Project	IEEE 802.16 Broadband Wireless Access Working Group < http://ieee802.org/16 >	
Title	AMC subchannel subcarrier allocation enhancements	
Date Submitted	2004-04-15	
Source(s)	<p>Panyuh Joo, Seungjoo Maeng, Jaeho Jeon, panyuh@samsung.com Soonyoung Yoon, Jeong-Heon Kim, Jaehyok Lee, Myungkwang Byun, Inseok Hwang, yigall@runcom.co.il Jaehee Cho, Jiho Jang, Sanghoon Sung, Samsung Electronics Co. Ltd. lim@etri.re.kr</p> <p>Yigal Leiba, Zion Hadad, Yossi Segal, Itzik Kitroser Runcom Technologies</p> <p>Choongil Yeh, Hyoungsoo Lim, Yuro Lee, Jongee Oh, DongSeung Kwon, ETRI</p>	
Re:	Sponsor re-circulation Ballot	
Abstract	AMC subchannel subcarrier allocation enhancements	
Purpose	Adoption of proposed changes into P802.16-REVd/D4-2004	
Notice	This document has been prepared to assist IEEE 802.16. It is offered as a basis for discussion and is not binding on the contributing individual(s) or organization(s). The material in this document is subject to change in form and content after further study. The contributor(s) reserve(s) the right to add, amend or withdraw material contained herein.

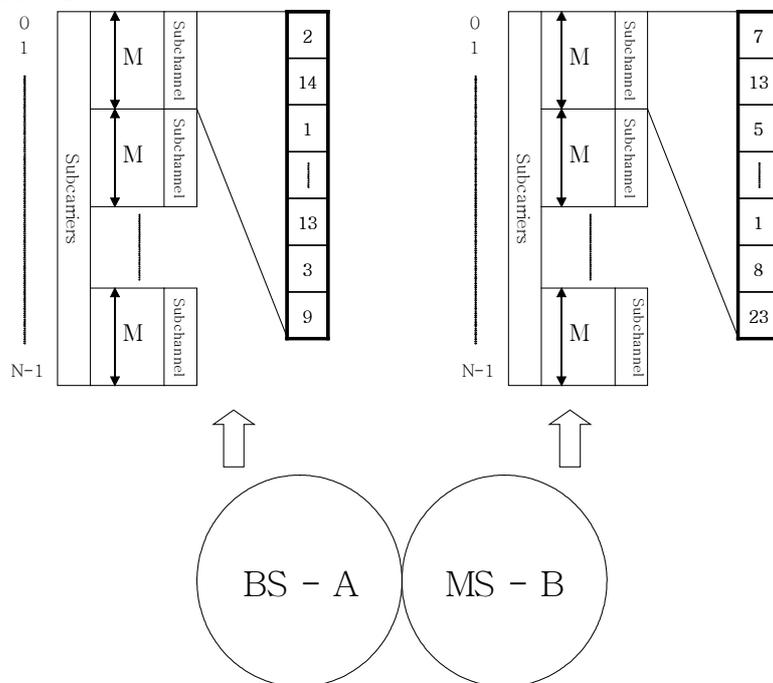
We propose to change the orders of subcarrier mapping within a AMC subchannel. The figure below illustrates the concept of subcarrier permutation. RS sequence defined GF(49) is used to provide systematic permutation per cell/sector.

Let the index of the traffic subcarriers be numbered from 0 to 47 within an AMC subchannel. The index of first traffic subcarrier in the first bin is 1, next one is 2 and so on. The index of the subcarriers increases along the subcarriers first then the bin. The j -th symbol of the 48 symbols where a band AMC subchannel is allocated is mapped onto the $(S_{per}^{off}(j) - 1)$ -th subcarrier of a subchannel. j is $[0, 47]$.

$$S_{per}^{off}(j) = \begin{cases} P_{per}(j) + off & P_{per}(j) + off \neq 0 \\ off & P_{per}(j) + off = 0 \end{cases}$$
